Safety Recall Launch Notification

Campaign #	NHTSA ID / CA DMV #	Description
2026010001	25V865	25P5491322

Check and Rework Transmission Wiring Harness

CAMPAIGN NO.	2026010001
CAMPAIGN DESC.	25P5491322
NHTSA ID	25V865
SUBJECT	Check and Rework Transmission Wiring Harness
MODEL(S)	AMG E 53 Hybrid 4MATIC+ (214 platform)
MODEL YEAR(S)	2025
CAMPAIGN POPULATION	117

**Figure 1 – Red (1): Power supply line
Green (2): Signal wires**

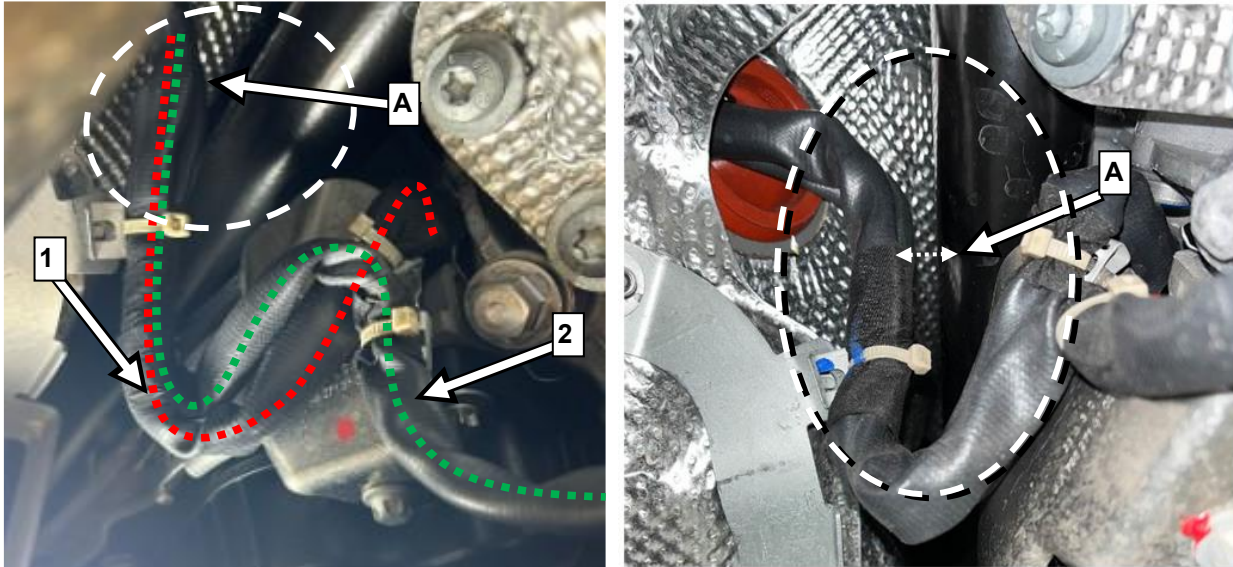
1. Check routing (**Figure 1, 1 & 2**) and distance (**Figure 1, A**) of the electrical wiring harnesses between the transmission tunnel/drive shaft and transfer case to front axle differential [*indicated parts*].

The electrical wiring harnesses **must not** make contact with the indicated parts.

The distance from the electrical wiring harness to the drive shaft must be **at least 10 mm**.

- a. If electrical wiring harness is in contact with indicated parts or the distance (**Figure 1, A**) is less than 10 mm and wiring harness is **not damaged**: Perform **Work Procedure 1**.
- b. If electrical wiring harness is in contact with indicated parts and **it is damaged**: Perform **Work Procedure 1** and **Work Procedure 2**.
- c. If electrical **power supply line (Figure 1, 1) (line cross-section 10 mm²) is damaged**: Perform **Work Procedure 1** and **Work Procedure 3**.
- d. If electrical wiring harness is ***routed correctly***: **End measure**.

Figure 2

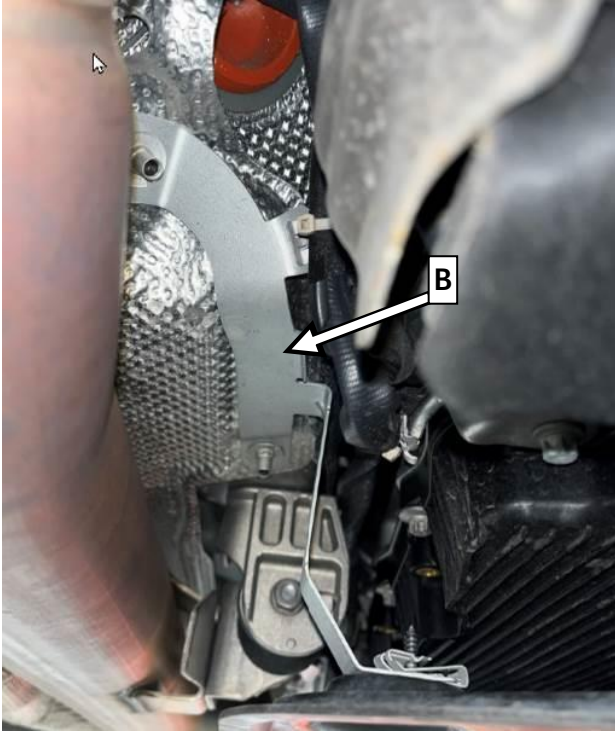
1. Remove holder (**Figure 2, B**) for attaching wiring harness and engine compartment lining.

Figure 3

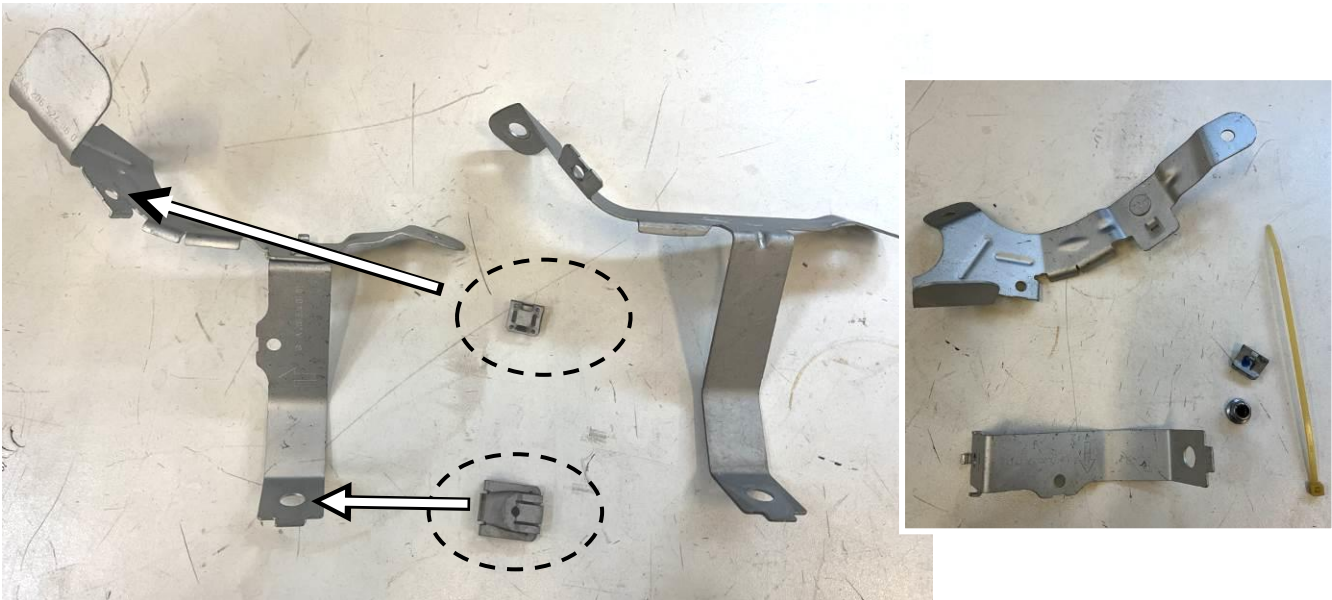
2. Remove retaining clamp for wiring harness and single-thread nut for engine compartment lining from detached holder and slide onto new modified holder (**Figure 3**).

Figure 4

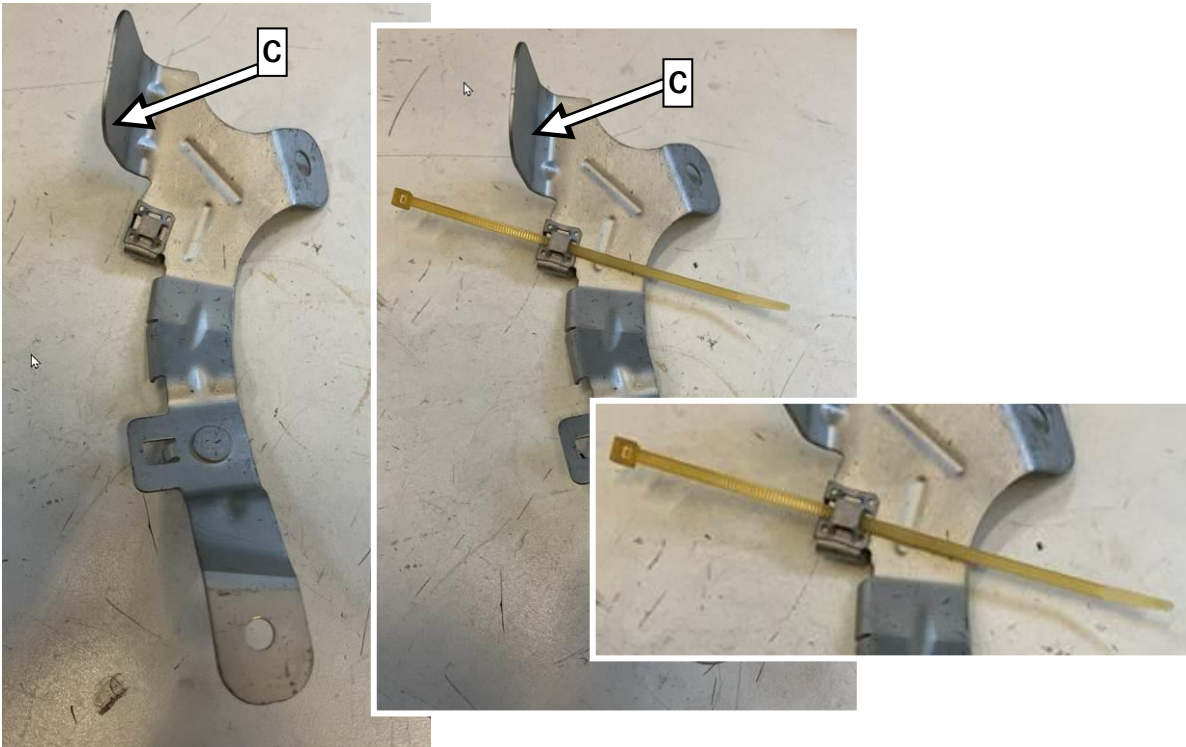
3. Install new holder (**Figure 4**) with preassembled cable tie.

i Cable tie is mounted on upper side of retaining clamp.

Figure 5

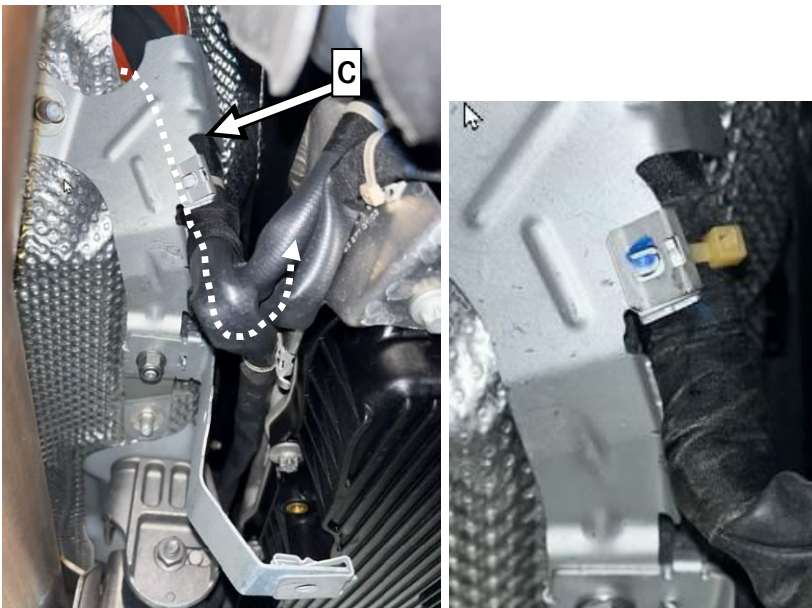
4. Attach wiring harness for automatic transmission, free of tension, using preassembled cable tie.

i The wiring harness now runs behind the tab (**Figure 4 and 5, C**).

Figure 6

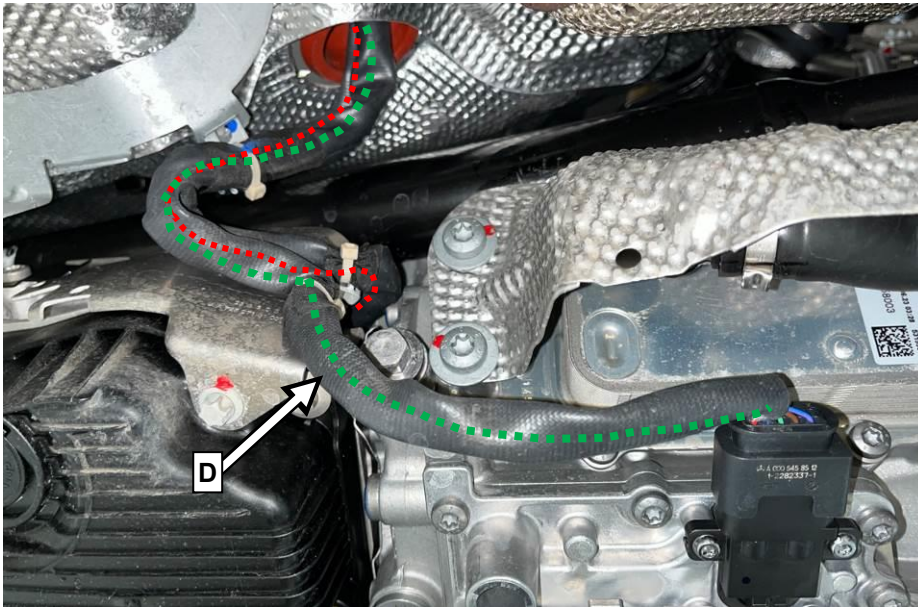
Electrical wiring harness is in contact with indicated parts and ***is damaged (chafed, melting, tears/scoring)***.
If only the protective sheathing is damaged, and the electrical wiring has no signs of damage:

1. Wrap affected area with fabric tape.
2. Route electrical wiring harness (**Figure 6, D**) correctly as shown.
 - i** The electrical wiring harness (**Figure 6, D**) must not be in contact with indicated parts ***in any location!***

i One or more of the electrical signal lines (**line cross section 0.35 mm² to 0.75 mm²**) in the electrical wiring harness (**Figure 6, D**) shows signs of damage.

1. Repair the affected electric signal line (**line cross-section 0.35 mm² to 0.75 mm²**) in the electrical wiring harness (**Figure 6, D**) using a line connector.
 - i** For basic information, see **AR00.19-P-0100A**.
 - i** To do this, cut the protective sheathing, repair the wiring harness using line connector(s), and reinstall protective sheathing using fabric tape to connect the cut sides.
2. Route electrical wiring harness (**Figure 6, D**) correctly, as shown.
 - i** The electrical wiring harness (**Figure 6, D**) must not make contact ***at any point!***
3. Assemble in reverse order.

Figure 7

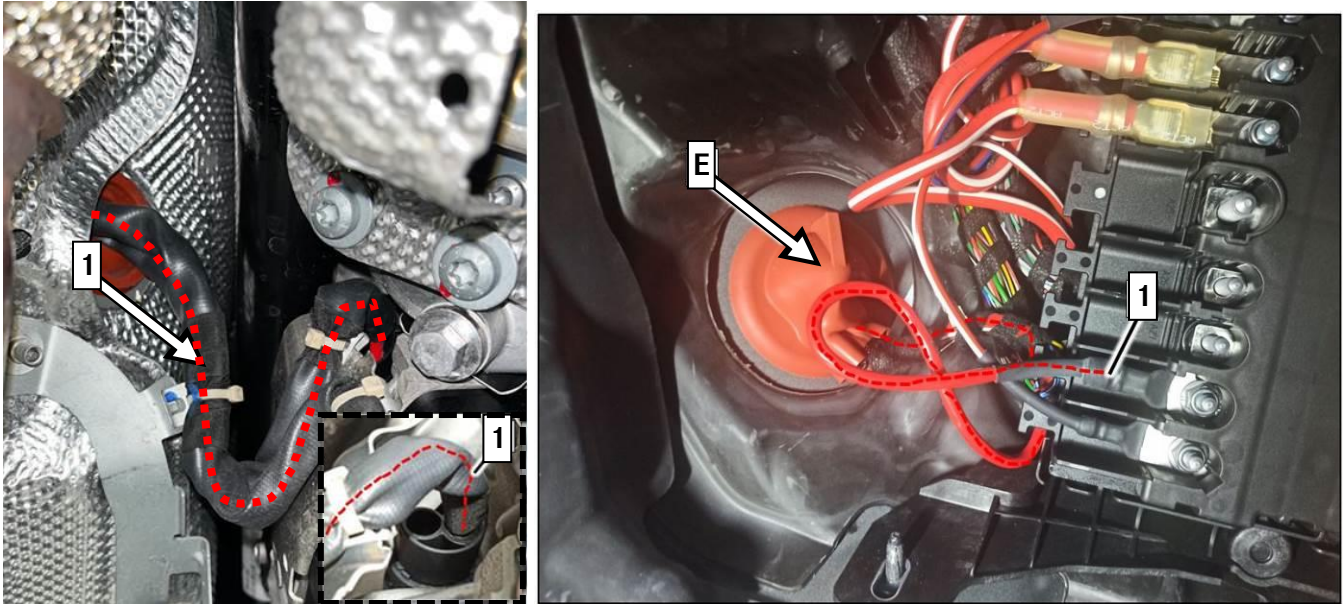
i If the electric power supply line (Figure 7, 1) (line cross-section 10 mm²) is damaged, replace electric power supply line (Figure 7, 1):

1. Disconnect ground line of 12 V electrical system battery.
i For basic information, see **AR54.10-P-0051WT**.
2. Remove rear section of underfloor paneling.
3. Remove protective metal sheet (Figure 8, F).
4. Detach electric power supply line (Figure 7, 1) from electrical connector on transmission.
5. Remove front floor covering on front passenger side.
i For basic information, see **AR68.80-P-0008WT**.
6. Remove electric power supply line (Figure 7, 1) with grommet (Figure 7, E).
7. Replace electric power supply line (Figure 7, 1).
i The electrical wiring harness **must not** be in contact with indicated parts at **any location**.
8. Assemble in reverse order.
